Office Action Summary

10/531,104

DETAILED ACTION

Fig. 3

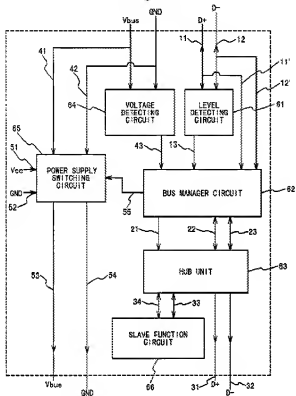
With regard to claim 1, Oguma discloses a device operable as a host device (as shown generally in Fig. 3, which is reproduced below for ease of convenience and reference, the portable device comprises a bus manager circuit can be operable as a host device)

comprising: a port connected to a bus (as shown in Fig. 3, USB port of the portable device provides connection to the USB bus comprising Vbus, GND), means for detecting the presence of another host connected to the bus and for relinquishing host status in response thereto (the voltage detecting circuit 64 is readable as the so-called "means for detecting." When the detecting circuit 64 detects presence of another host 1 connected to the USB bus, the host status of the portable device is relinquished. See at least column 2, lines 39-57, column 4, line 65 to column 6, line 17).

Fig. 3

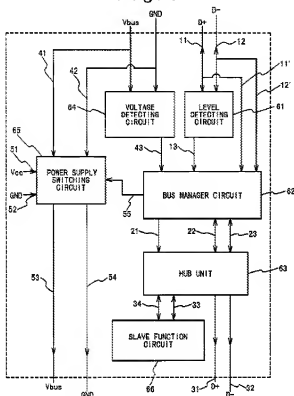
Thus, contrary to Applicants' argument, Fig. 3 of Oguma, which is reproduced below for ease of reference and comparison, shows the so-called "device operable as a host." Further as shown in Fig. 3, the device includes a USB bus comprising Vbus,

GND, D+, and D-. The device further comprises a first upstream port connected directly to the USB bus; and a second downstream port connected directly to the same USB bus running from the first upstream USB port to the second downstream USB port. The device as shown in Fig. 3 of Oguma also shows the so-called "host module" or bus manager circuit 62 connected directly to the same USB bus; and the "comparator" or voltage circuit 64 detecting coupled to the same USB bus to detect the presence of a host externally connected to the USB bus. A voltage detecting circuit basically comprises a voltage comparator for comprising a supply voltage with a reference voltage (VREF) to detect a change in voltage or a difference between supply voltage and reference voltage. Further, as noted above, a USB bus comprises Vbus, GND, D+, and D-. It is also important to note that Applicants' Fig. 3 shows a Vbus line, and other lines are grouped together as line 40.

Further, Applicants have argued that “Oguma imposes intervening components and circuits (which include bus manager circuit 62, hub unit 63, and power supply switching circuit 65) to perform any sort of pass- through function.” In response to Applicants’ argument, at the outset, it is noted that Applicants have acknowledged that the signal is indeed passed through from host to device without any modification to the signal. **As a matter of fact, Oguma clearly discloses that the bus manager circuit 62 only passes the USB signals. See column 4, lines 18-22.** Thus, USB data are communicated between the slave function circuit 66, the host personal computer 1, and the third external device 6 via the USB hub unit 63. In any event, the USB Hub is simply used to increase the number of USB ports; and USB data passes through the USB hub

unchanged. As a matter of fact, the USB hub, by definition, is essential transparent. What is sent by the host is received by the device. See definition of USB Hub provided by Wikipedia, cited below. Thus, it is clear that the bus manager circuit 62 as well as the hub 63 allow the USB data to pass through directly from the host to the device without any USB signal intervention and/or modification. In other words, the USB data bus passes the USB signal directly from the first port to the second port (the ports are used to connect the host to the device) in response to the relinquishment of host status. It is still the Examiner's position that the definition on Wikipedia is just a quick and convenience way to point out to Applicants the fact USB Hub is a notoriously old and well-known device, and that USB Hub, by definition, is essentially transparent and must meet all requirements set forth and defined in the USB specification. Referring again to Wikipedia document, the definition of USB Hub is also based on the "Universal Serial Bus Specification," which exists as early as 4/27/2000 (see "USB 2.0 specification" under "References). In other words, contrary to Applicants' argument that the USB Hub was "developed after the instant application's priority date," the USB Hub exists as early as 4/27/2000.
